### **Dredge Licence Application**

## Appendix A Screening Opinion Query Responses

The screening opinion for this project (SCR-0081) was returned on 2nd July 2024 and confirmed that an EIA would not be required for sea disposal provided that the mitigation detailed in the accompanying reports was implemented.

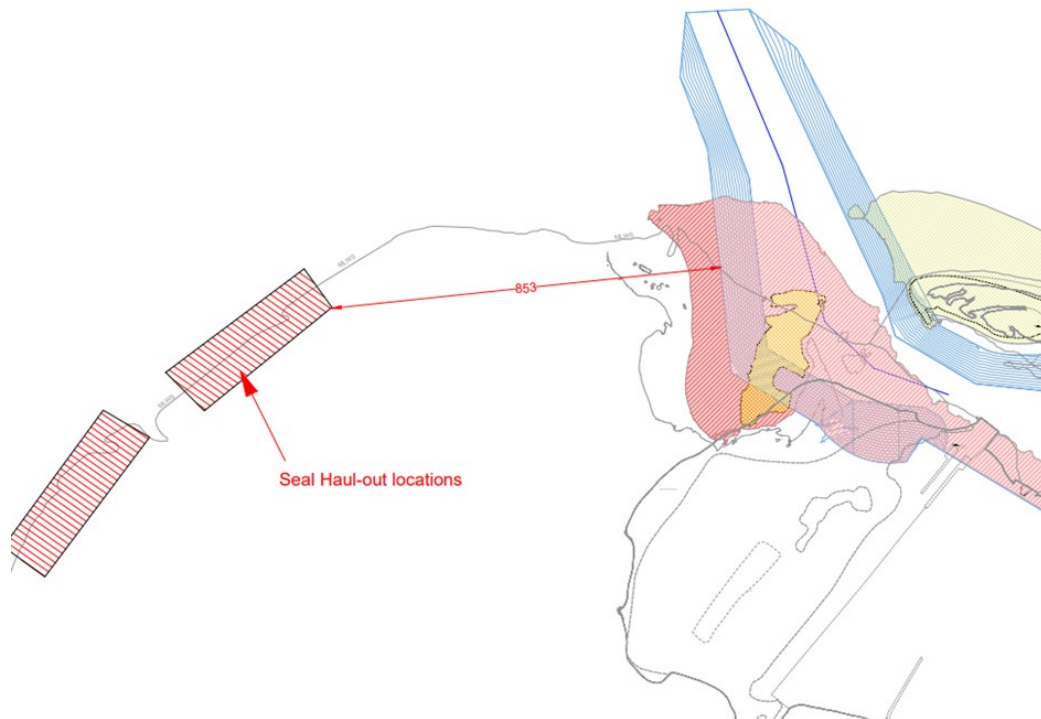
*We note that two licenced offshore disposal sites are identified, with Burghead being the preferred option to the Sutors. It is possible that some Moray Firth SPA waterbirds may still be present in good numbers between Port of Ardersier and Burghead/Sutors. We know that both disposal areas can be favoured by Seaduck, potentially into April. Therefore, if it was possible for early disposal of material from the outer dredge channel to be redirected to Whiteness Sands and Spit Reinstatement Zones, perhaps during April, then that could help to reduce any disturbance and/or displacement effects to non-breeding SPA waterbirds that may be frequenting within the vicinity of disposal locations.*

- It is currently expected that pump ashore to the existing dredge sand storage area, Whiteness sands nourishment and spit reinstatement will all take place early in the dredge programme. Currently we therefore do not anticipate disposal at Burghead in April 2025.

Drawing title  
**SPIT REINSTATEMENT INFORMATION**

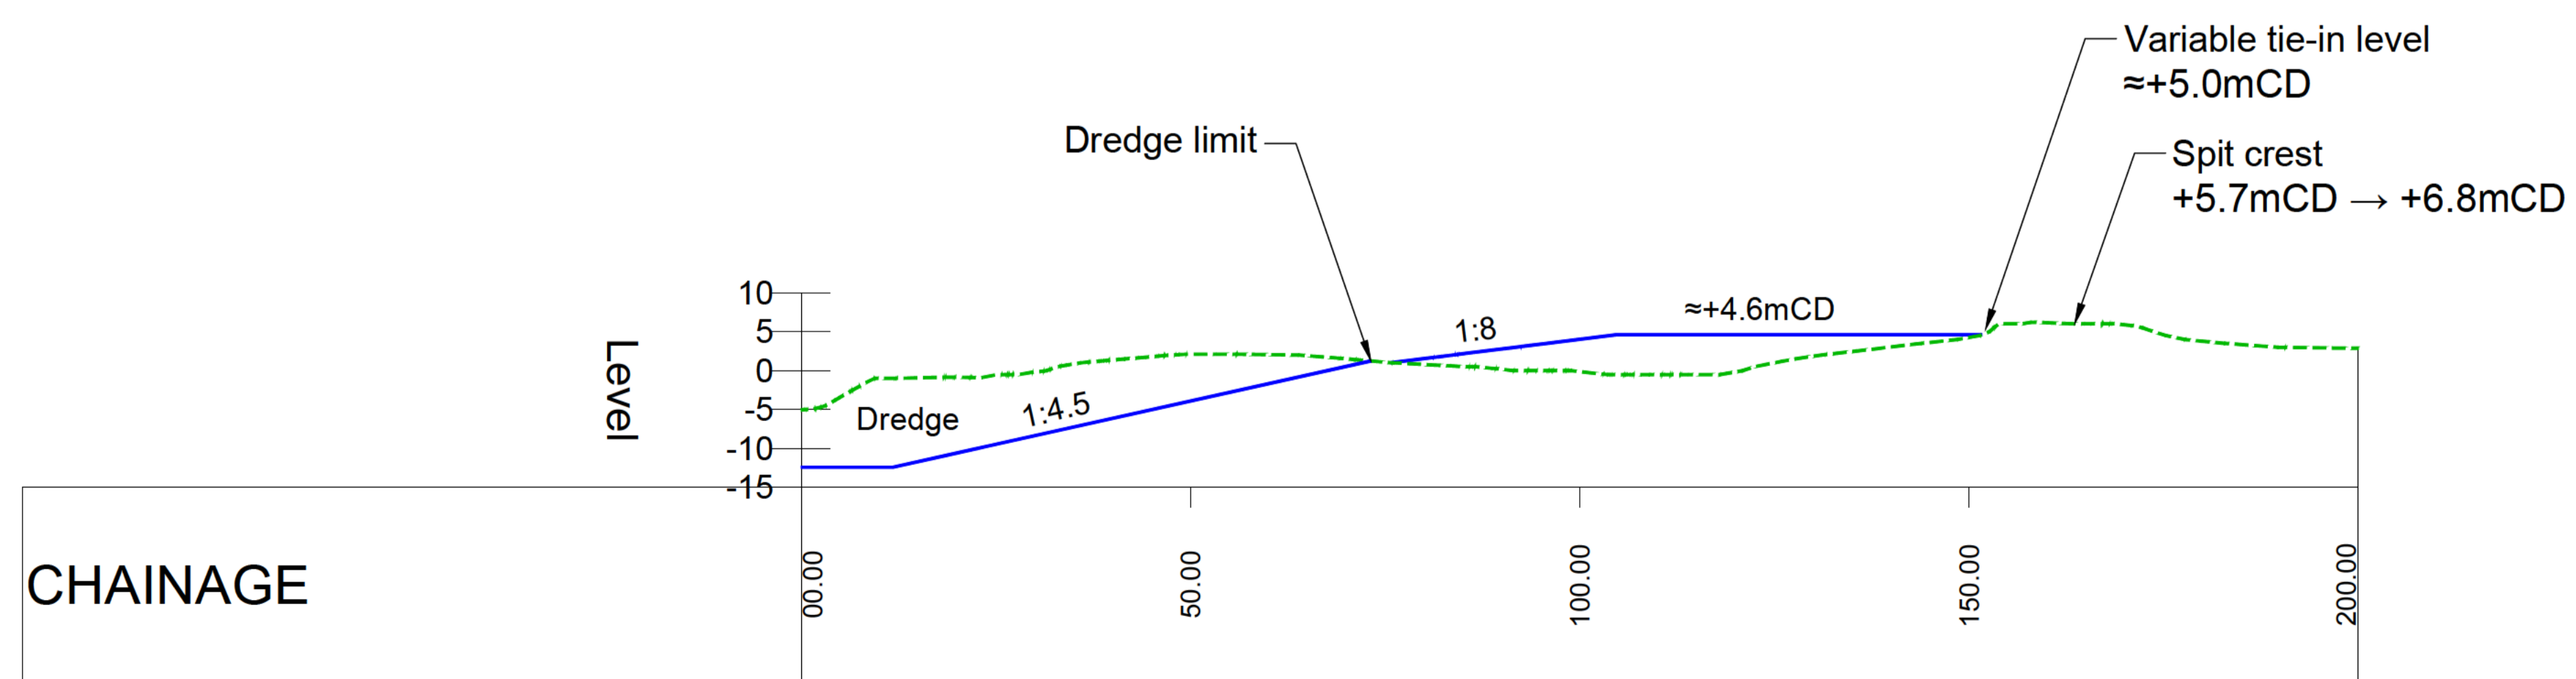
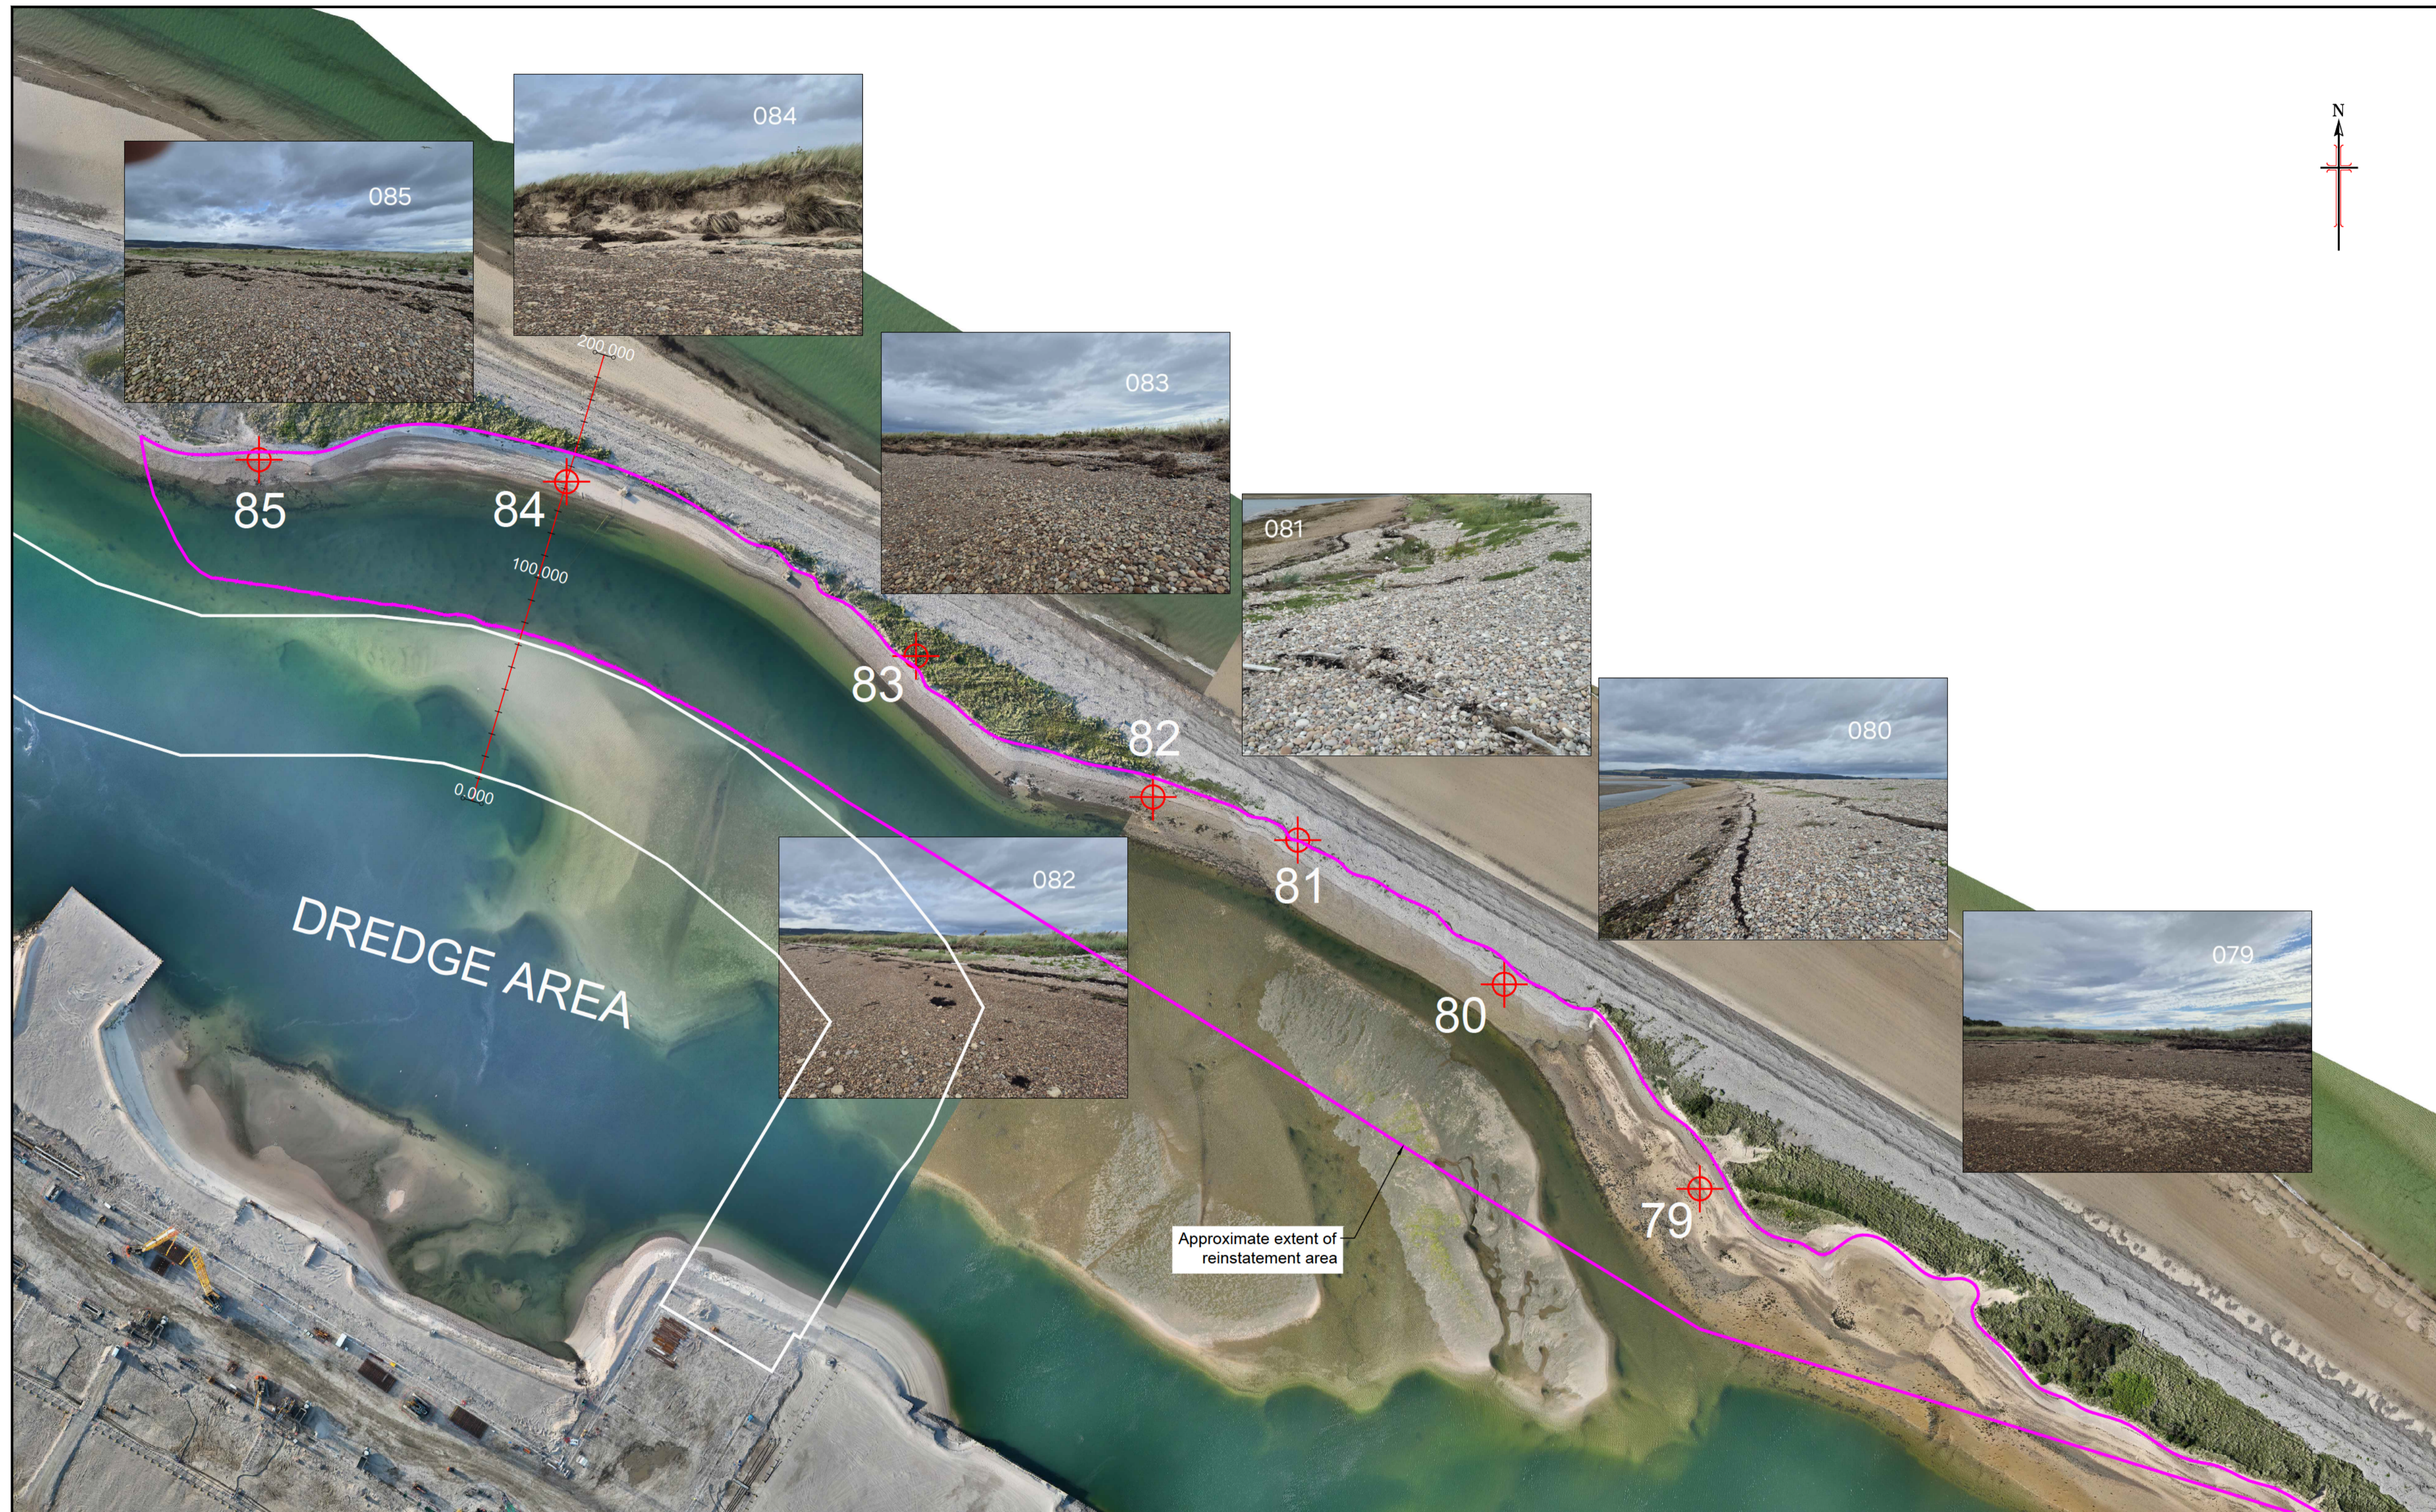
*We would welcome a detailed method statement for spit reinstatement of both the western and eastern scallops, encompassing mapping, cross-sections, and methodology (this may match the CEMP proposed in Appendix F of the BPEO (p.436).*

- A method statement was prepared by Haventus based on discussions with dredging contractors which describes how the reinstatement will be undertaken. This has already submitted directly to NatureScot for their consideration and is contained in Appendix B of this document titled ‘Spit Reinstatement Method Statement’.

### **Representative Section**

- The attached drawing shows a representative section through the location of Photo 084 above and photos from various locations, approximate extent of reinstatement area and Phase 1 dredge;
- The heights and shape of the profile within the representative section is consistent with that shown in the 2017 Harbour Revision Order Drawings;
